Rasp Mine Project - Modification 9

Extension of Underground Exploration

State Significant Development Modification Assessment (07_0018 MOD 9)

December 2021

Figure 3 | Proposed development drives and EEL

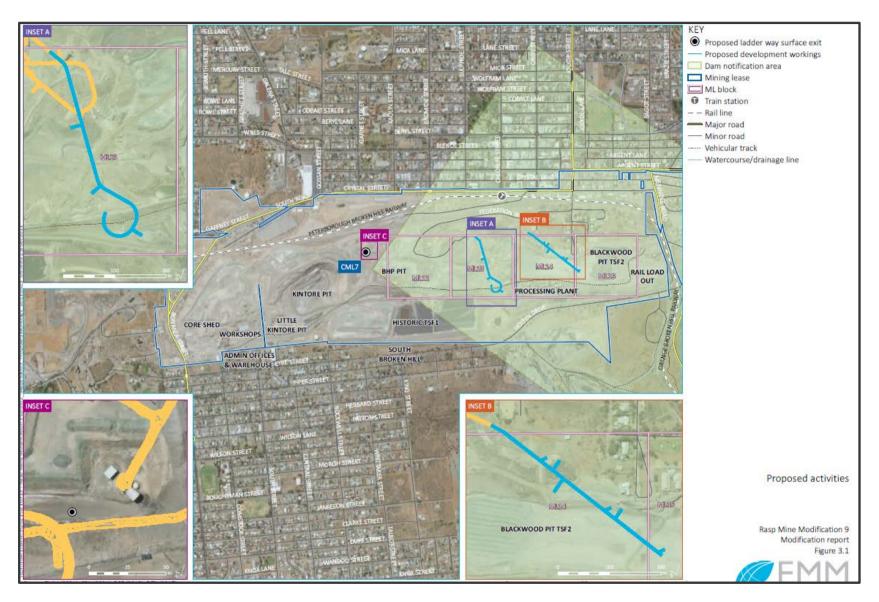
Issue **Findings Recommended Conditions** Geotechnical • The location of the proposed development drives poses some geotechnical hazards due to No additional conditions required. stability their position partially below TSF2 (Blackwoods drive only - see Figure 3 Inset B) and historical workings (both drives). Key potential hazards include: liquefaction of tailings and damage to the TSF2 structure and spillway; and water inrush from historical workings; Potential instability was also identified in the upper section of the proposed EEL. The Modification Report concluded that risks associated with the proposed development drives primarily relate to blast vibrations. However, BHOP advised that geotechnical risks would be minimal due to the size of pillars between development workings, TSF2 and historical workings. The Department's assessment of blast impacts is considered further below. BHOP advised that geotechnical probe drilling and monitoring would be undertaken in accordance with current site management protocols to detect and manage unexpected instability. BHOP also propose to conduct a camera survey in the upper section of the proposed EEL location to confirm if any additional support is required. MEG and Resources Regulator raised no issues regarding geotechnical stability. The Department notes that mining operations and safety are regulated under the Work Health and Safety (Mine and Petroleum Sites) Act 2013 and other Work Health and Safety legislation. The Department considers that geotechnical risks associated with the proposed modification

could be appropriately managed through careful design and control procedures.
